TO: Plan Commission
FROM: Kevin Briski, Parks Superintendent
DATE: October 29, 2013
SUBJECT: Birchwood Point

PROJECT:
BIRCHWOOD POINT PLAT

SHEET TITLE:
SITE PLAN

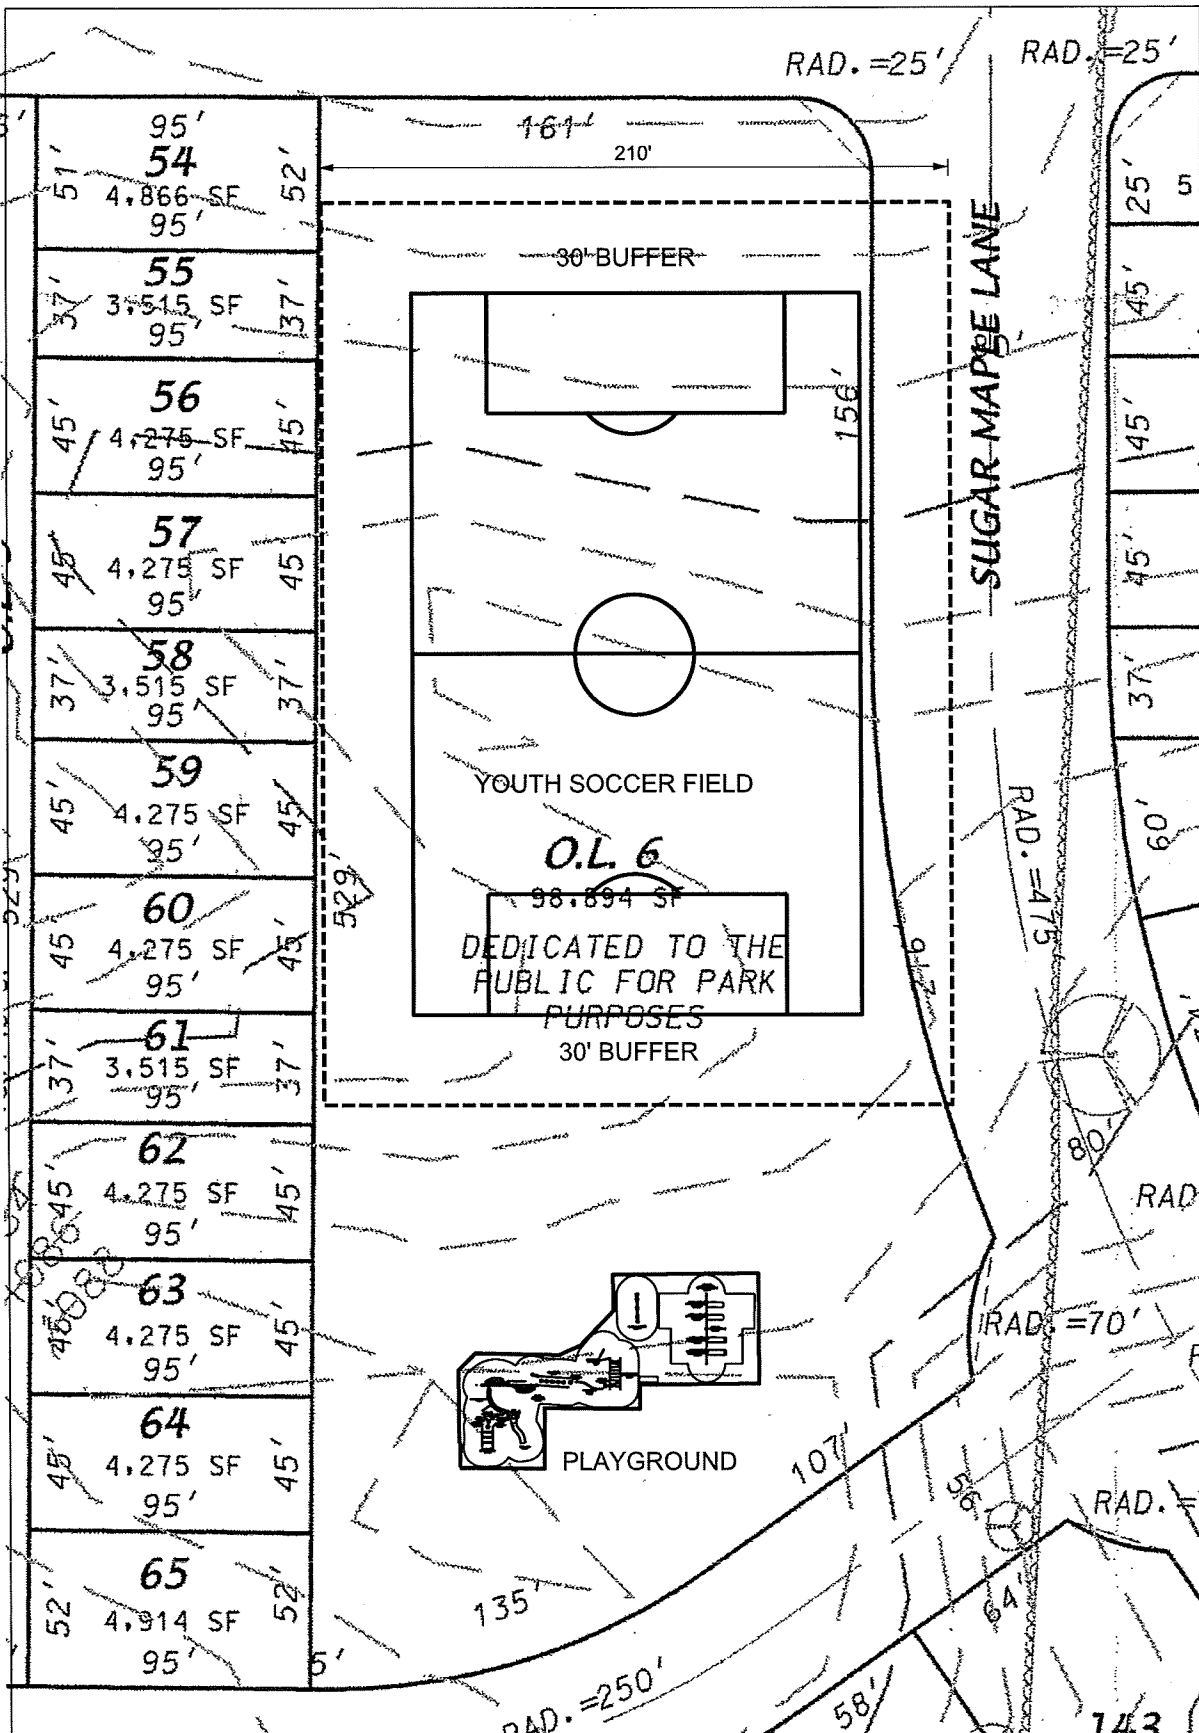
Outlot 6 as currently configured will not allow the Parks Division to develop public recreational amenities consistent with the adopted Park and Open Space Plan for a neighborhood park. The east-west dimension of Outlot 6 is not adequate to provide space for an open play field that can be used for youth-size soccer (see attached). The Parks Division is willing to accept Outlot 6 as public parkland if the east-west dimension is not less than 210 feet as shown on the attached exhibit. This distance cannot be encumbered with public sidewalks or any other hardscape; if public sidewalks are included with the parkland dedication, then the area to be dedicated should be increased to retain the dimension in unencumbered space identified above. No underground utility easements shall be located along the park perimeter unless approved by the Parks Division.
